**Grimes Planning & Zoning Commission Meeting October 1, 2024
In Person at Grimes Community Complex, 410 SE Main Street, Room 202**

Glass Fabricators Building
Addition
Site Plan Amendment

RE: Glass Fabricators Building Addition Site Plan Amendment

The Development Services Department is in receipt of a proposed Site Plan Amendment for Glass Fabricators Building Addition. Based on the review of the provided submittal materials, staff have the following comments:

Sheet 3:

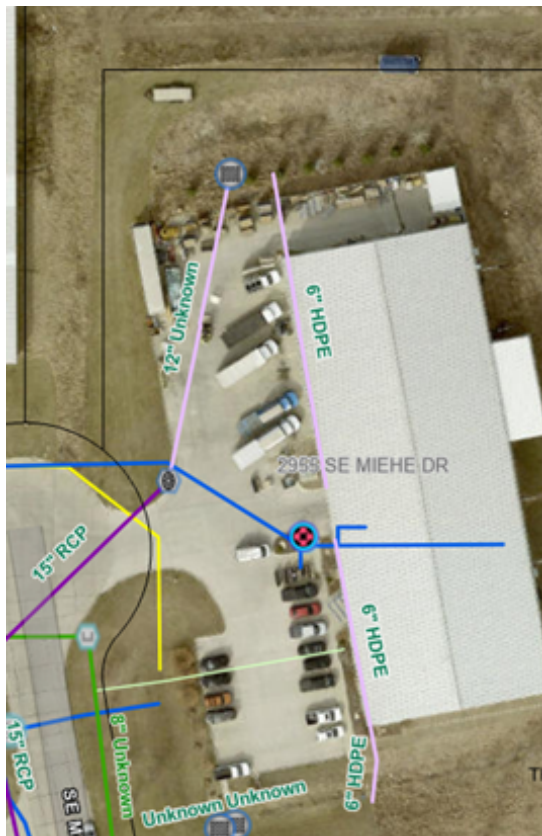
1. ~~Verify if there is storm sewer running along the face to the building to the northern detention basin.~~

2. There is existing outdoor storage. Will the outdoor storage be moved inside the building? Or will there still be outdoor storage areas? If yes, please show the location on the site plan and provide details for the outdoor storage screening. **All glass panes and other materials are required to be stored within the building or shed.**

3. Dumpsters are currently being stored outside. They will need to be stored inside the building otherwise a dumpster enclosure is required. Please provide enclosure details.

- a. **The dimensions of the dumpster enclosure do not match what is noted on the site plan. Please revise.**
 - b. **Dumpster enclosure height is required to be 6'-8' tall. Please revise.**

- c. **Dumpster enclosures are required to be constructed with masonry. Please revise.**
 - d. **Please label the material on the face of the gates. Material is required to be opaque. Chainlink with slats is not permitted.**

- e. **Gates are required to be metal framed. Please label.**
4. ~~Show all parking striping, including ADA.~~
5. ~~Label the width and depth of truck parking.~~

6. ~~Label ADA parking signage.~~
7. Are there building changes on the rear of the building? The footprint shown does not match the existing footprint? **The footprint doesn't match. Please remove/revise.**

8. ~~Staff would suggest installing a stop sign out to SE Mische Dr.~~
9. ~~There appears to be two boats and/or trailers parked on the north side of property, and on the adjoining vacation property. Please remove from the property, or store upon an approved paved surface and in an approved outdoor storage area.~~

10. **Why are the two southern parking stalls striped out? Based on the square footage of the building, one of the spaces is required to be provided as parking.**

11. **Please label the future 5' sidewalk in the ROW.**

Building Elevation:

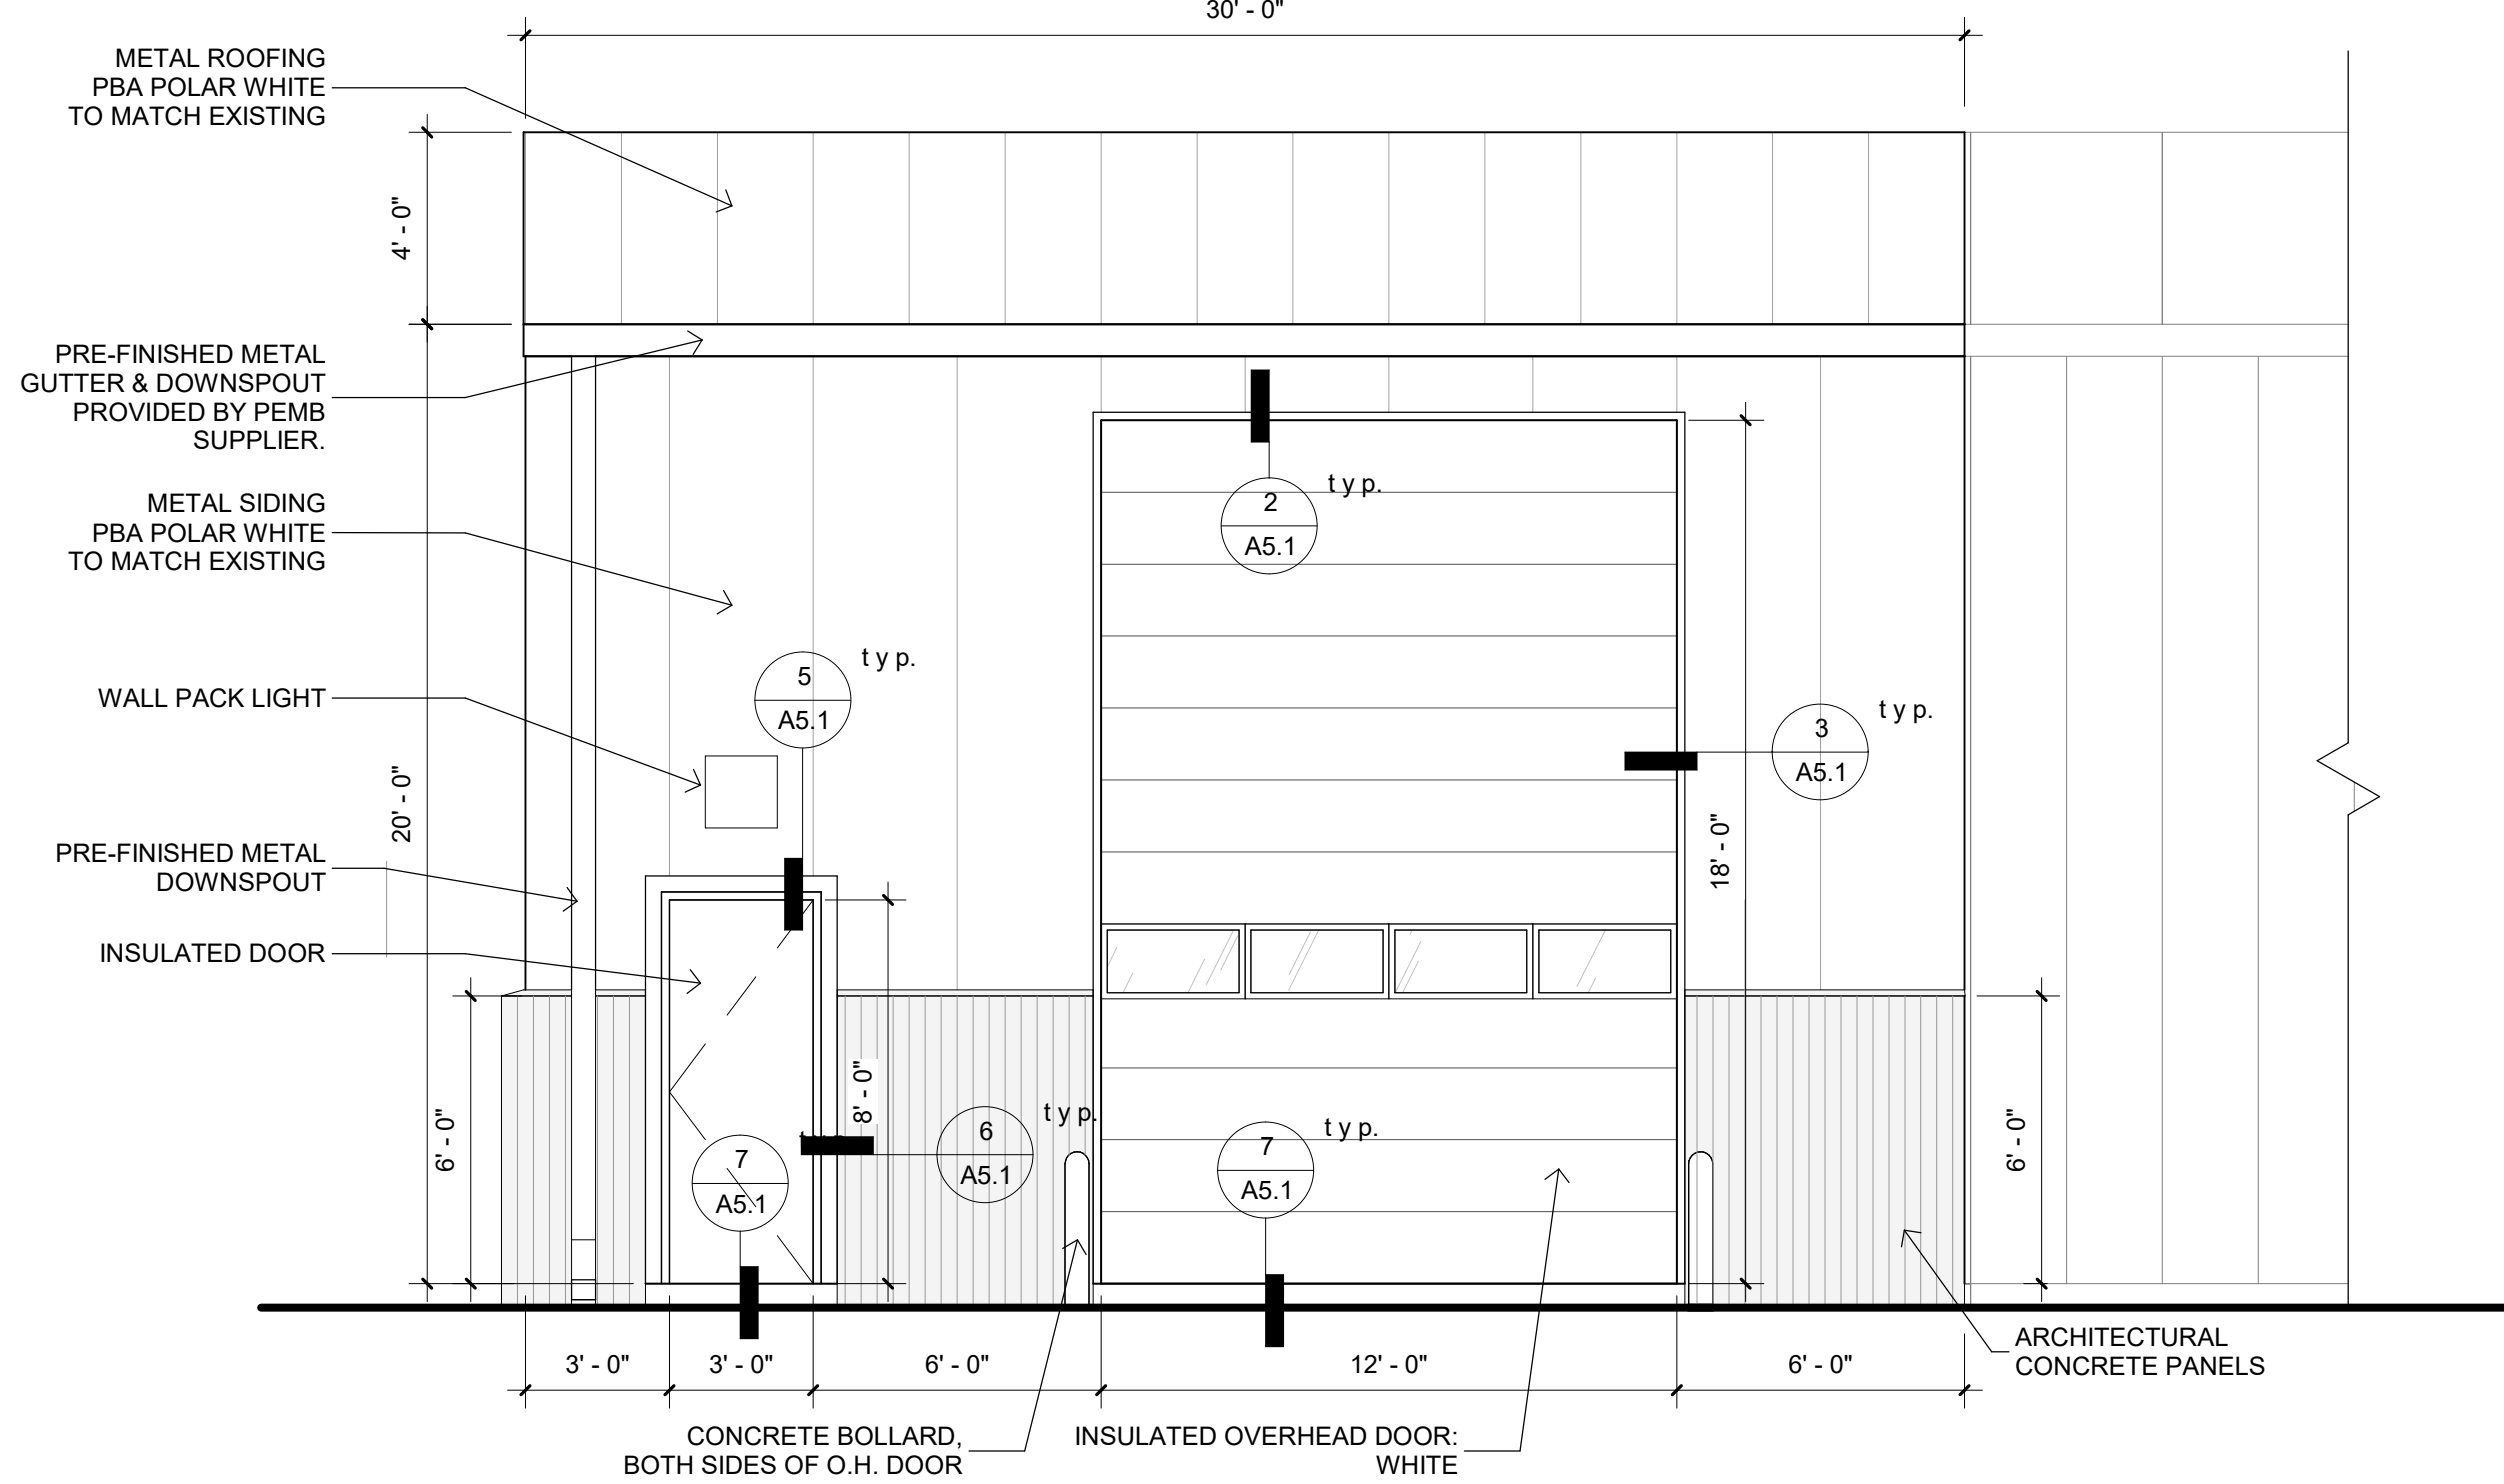
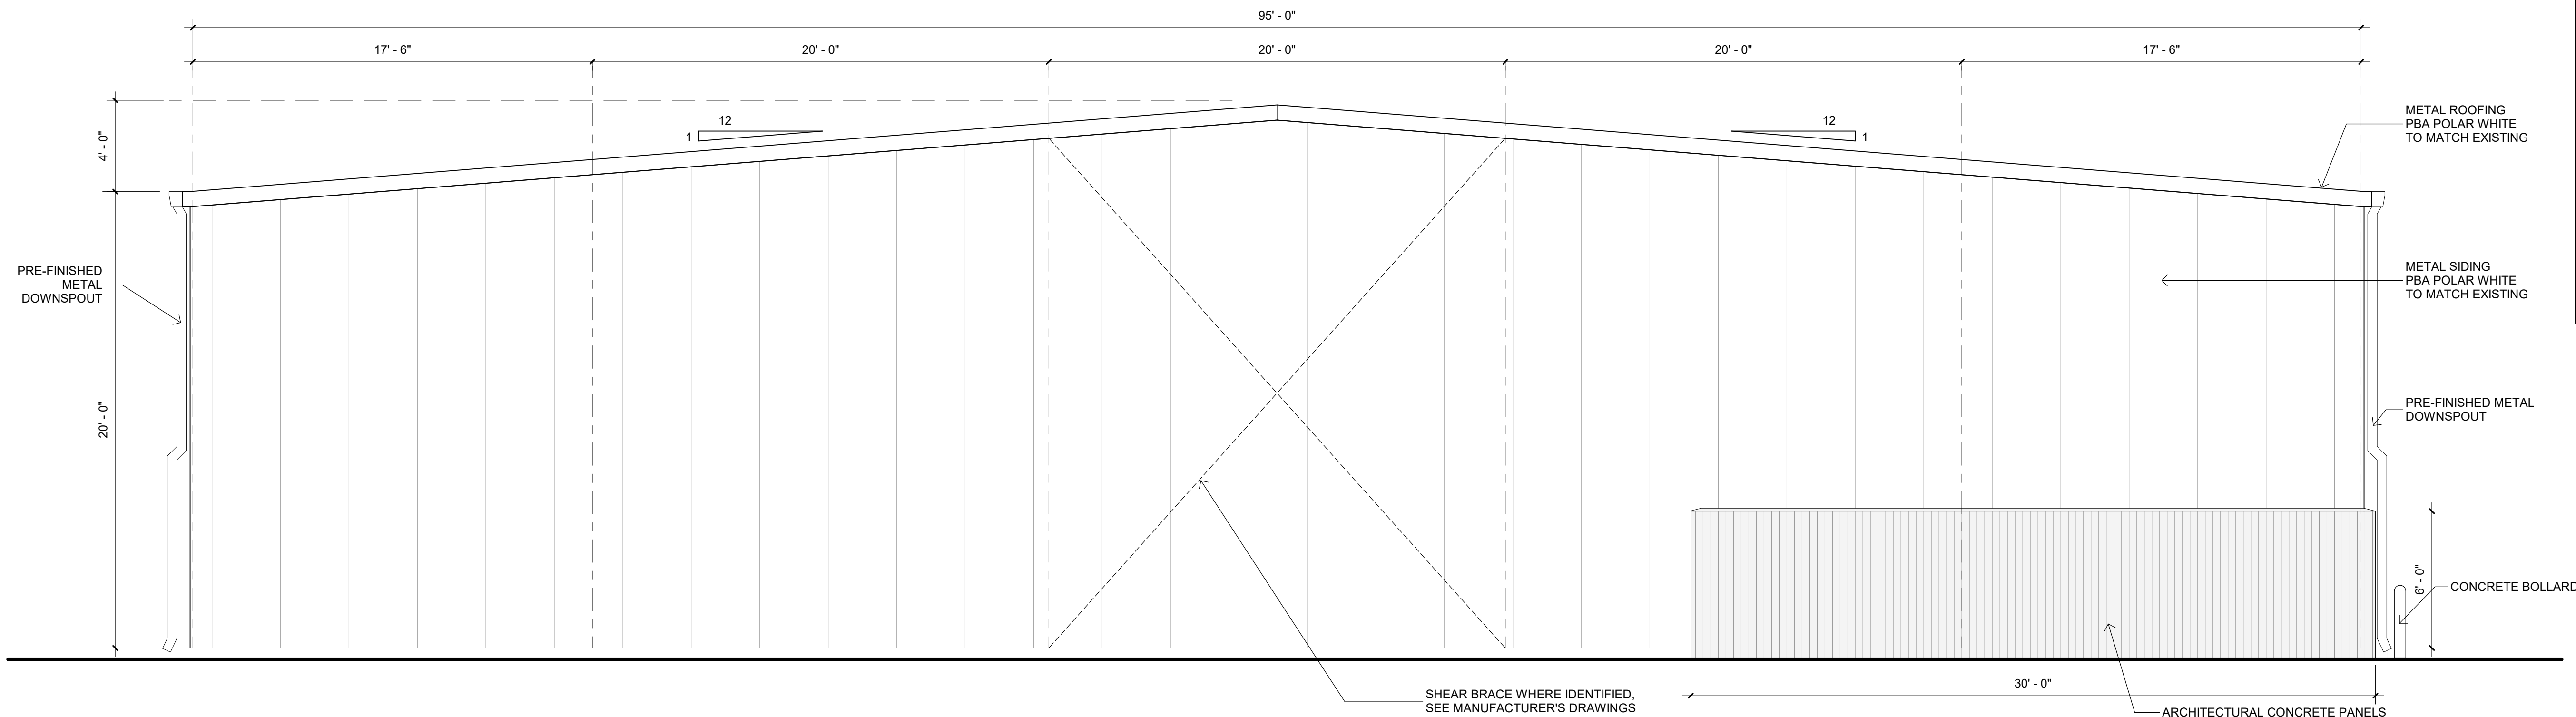
1. ~~Provide landscaping to obscure the loading area and overhead doors from SE Mische in the area identified below.~~

2. ~~Is any roof-mounted equipment proposed? If so, please show locations and screen to hide from SE Mische Dr.~~
3. Please specify the color/spec for the architectural concrete panel.
